DUTCH BROS. COFFEE - CO0907, COLORADO SPRINGS, CO

A PORTION OF THE SOUTHWEST QUARTER OF SECTION 6 TOWNSHIP 14 SOUTH, RANGE 65 WEST OF THE 6TH PM  
CITY OF COLORADO SPRINGS, COUNTY OF EL PASO, COLORADO  
PCD FILE NO PPR2413

Title: STRIPING PLAN - OMAHA BLVD  
5810 OMAHA BLVD  
COLORADO SPRINGS, CO 80915

# V3\_Grading Plan.pdf Markup Summary

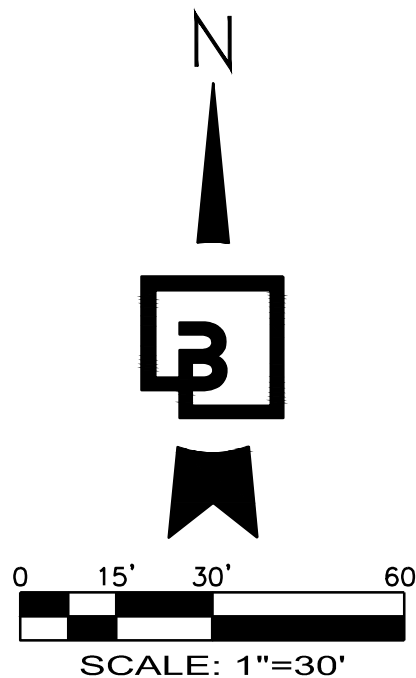
Unresolved: Please clarify if this fits within the existing asphalt width. EPC measured existing roadway width at this location is 52 feet. The proposed dimensions equal 54.9 feet. Consider shifting all proposed striping to the south and also shift the existing EB left turn bay striping to match the new alignment.

Please remove the R4-1 sign

Unresolved: Please clarify if this fits within the existing asphalt width. EPC measured existing roadway width at this location is 52 feet. The proposed dimensions equal 54.9 feet. Consider shifting all proposed striping to the south and also shift the existing EB left turn bay striping to match the new alignment.

Please relocate or add per MUTCD guidance to the upstream end of the mandatory turn movement, section 2B.28(04)
